**Re: GE-Pittsfield/Housatonic River Site
Newell Street Area I (GECD440)
Restoration of Parcel J9-23-22**

To reflect these changes, Technical Drawings 6, 12, 13, and 14 of the August 2003 *Final RD/RA Work Plan* have been revised and included herein. In addition to these revisions, Technical Drawing 12A was developed to present certain restoration details associated with the drainage swale, among others.

**PHASE IV
EXCAVATION LIMITS**
TECHNICAL DRAWINGS

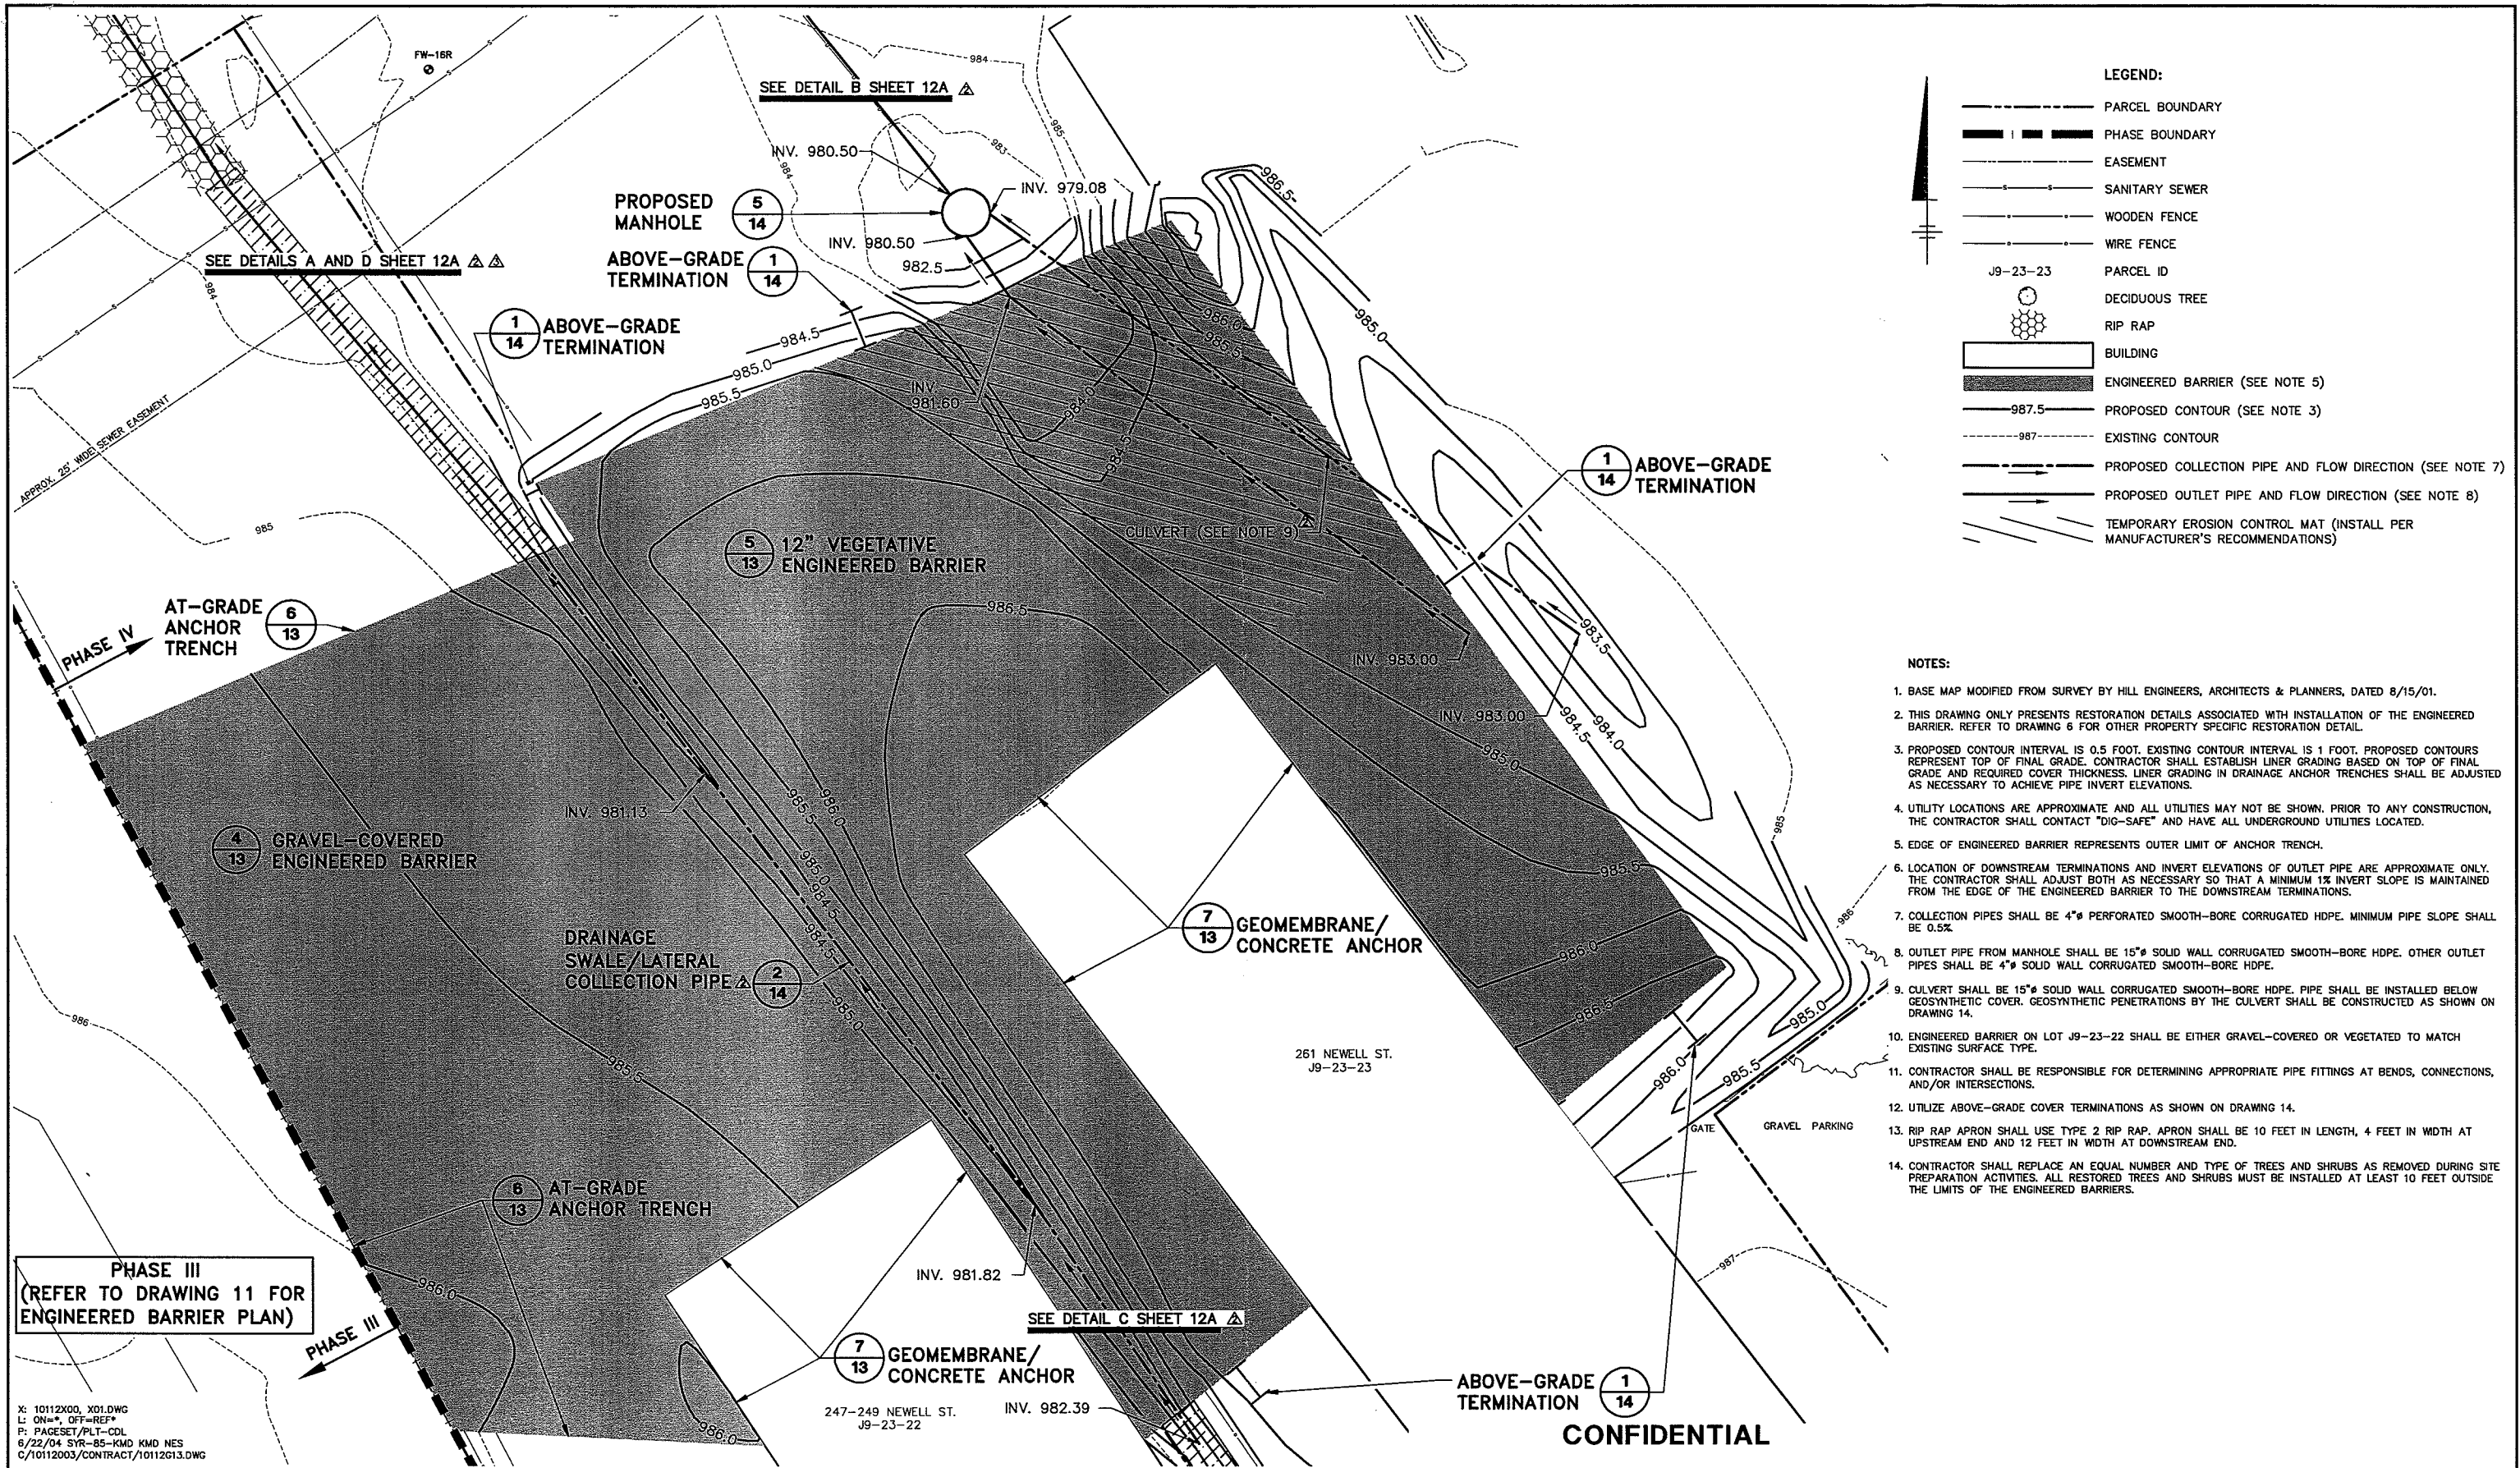
CONTRACTOR SHALL REMOVE GRAVEL DRIVE WITHIN HATCHED AREAS. CONTRACTOR SHALL DISPOSE OF ALL REMOVED MATERIALS ALONG WITH ADJACENT EXCAVATED SOILS (SEE NOTE 3). CONTRACTOR SHALL RESTORE THIS AREA WITH A 1 FOOT COMPACTED PROCESSED GRAVEL BASE AND A 2-INCH THICK NON-RESIDENTIAL ASPHALT WEARING COURSE. CONTRACTOR SHALL RESTORE AREA TO ALLOW POSITIVE DRAINAGE OF SURFACE WATER TOWARD DRAINAGE SWALE LOCATED ADJACENT TO EAST/SOUTHEAST CORNER OF REAR BUILDING. CONTRACTOR SHALL RESTORE REMAINDER OF PROPERTY FROM SIDE OF REAR BUILDING TO REAR PROPERTY LINE WITH A SIX-INCH COMPACTED GRAVEL LAYER. (SEE TECHNICAL DRAWINGS 12, 12A, 13, AND 14 FOR ADDITIONAL RESTORATION DETAILS IN ENGINEERED BARRIER AND DRAINAGE SWALE AREAS.)

No.	Date	Revisions	Init
1	6/22/04	ADDED NOTE REGARDING RESTORED SURFACE COVER	CRA
2	5/26/04	MISCELLANEOUS RESTORATION-RELATED CHANGES	CRA
3	10/15/03	DELETED NOTE REGARDING FUTURE BUILDING	CRA
DEMOLITION ACTIVITIES:

CHECK DAM CROSS-SECTION

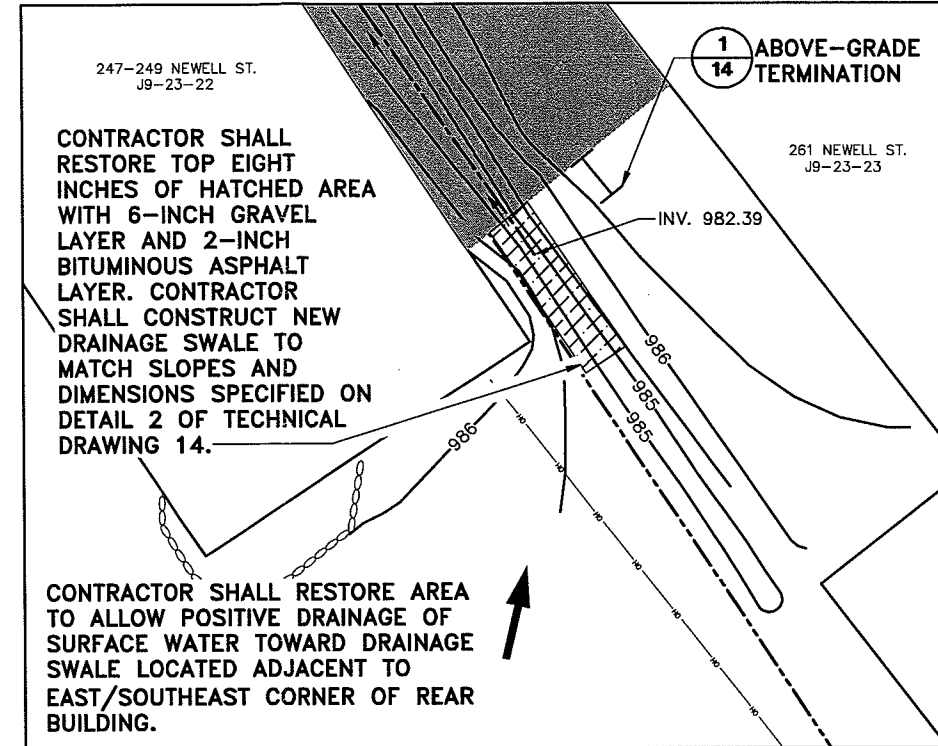
As indicated above, the change in surface cover conditions associated with site restoration will result in a minor increase in peak discharge runoff to the riprap outlet channel. Based on site conditions observed on June 17, 2004, the riprap channel constructed within the riverbank (i.e., the portion located below the crest of the riverbank) appears to be well established with no apparent signs of instability. Considering the current condition of the outlet channel and the anticipated minimal increase in peak discharge, the bank portion of the outlet channel should remain stable following completion of the site restoration activities. However, GE proposes to restore the riprap swale upgradient of the outlet channel (i.e., the portion located above the crest of the riverbank) in accordance with Detail D on Technical Drawing 12A to better contain and convey runoff to the riprap outlet channel. Finally, to further improve flow control within the riprap swale and outlet channel, GE proposes to install a check dam at a location approximately 5 feet upgradient of the riverbank crest. The cross-section of this check dam is also included in Detail D on Technical Drawing 12A.

- NOTES:**
- CHECK DAM TO BE INSTALLED APPROXIMATELY 5' UPGRADIENT OF THE RIVER BANK CREST.
 - CHECK DAM CREST TO HAVE A MINIMUM TOP LENGTH OF 12" AND A MINIMUM BOTTOM LENGTH OF 3".

No.	Date	Revisions	CRA	Init
1	6/22/04	ADDED DETAIL D.

DRAINAGE SWALE CROSS-SECTION

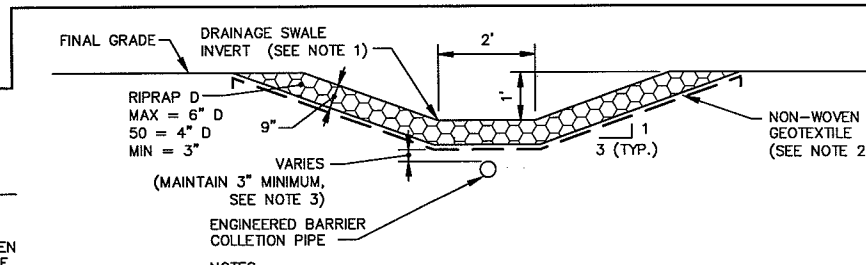
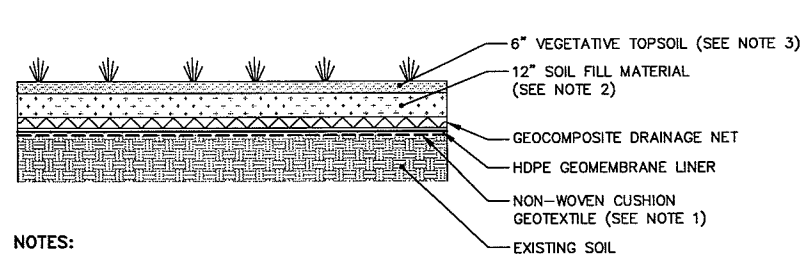
- The portion of the property located between the northern building and Newell Street will be restored with a compacted 12-inch processed gravel base followed by a two-inch layer of asphalt pavement.
- The portion of the previously unlined drainage swale extending from just south of the rear building to the riprap drainage swale at the rear of the property will be restored with six inches of compacted gravel and a two-inch layer of asphalt.

CONTRACTOR SHALL RESTORE TOP EIGHT INCHES OF HATCHED AREA WITH 6-INCH GRAVEL LAYER AND 2-INCH BITUMINOUS ASPHALT LAYER. CONTRACTOR SHALL CONSTRUCT NEW DRAINAGE SWALE TO MATCH SLOPES AND DIMENSIONS SPECIFIED ON DETAIL 2 OF TECHNICAL DRAWING 14.

- NOTES:**
- DITCH SHALL HAVE A MINIMUM SLOPE OF 1%.
 - GEOTEXTILE TO BE INSTALLED IN ACCORDANCE WITH MANUFACTURER'S SPECIFICATIONS. GEOTEXTILE TO BE OVERLAPPED ONTO EXISTING GEOTEXTILE AT RIVER BANK CREST A MINIMUM OF 18".
 - CONTRACTOR SHALL ENSURE THAT THE DRAINAGE PIPE FOR THE ENGINEERED BARRIER IS NOT DAMAGED DURING CONSTRUCTION OF THE DRAINAGE SWALE.

GRAVEL-COVERED ENGINEERED BARRIER 4
NOT TO SCALE

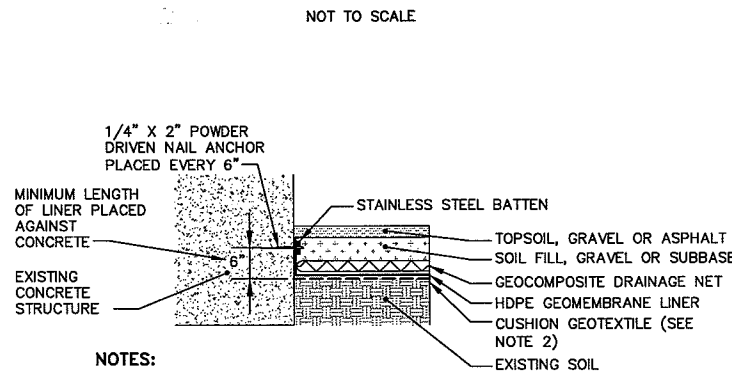
- The restored surface cover for the remainder of the property -- which includes the engineered barrier area -- will consist of a minimum six-inch compacted gravel layer. However, the area over the barrier will be restored with an 18-inch compacted gravel layer including a layer of geotextile located approximately six inches below grade, to serve as an indication when six inches of gravel have been displaced and maintenance activities are necessary.

Project Mgr.	CBA		
Designed by	BMS/CAA		
Drawn by	JER		
Checked by	JMN/WAR/PHB		
Prof. Eng.			
PE License			
		6/22/04	REVISED DETAIL 4
		9/24/03	REVISED DETAIL 1 AND DETAIL 5
			Revisions
			Init
			CRA
			CRA
			Init
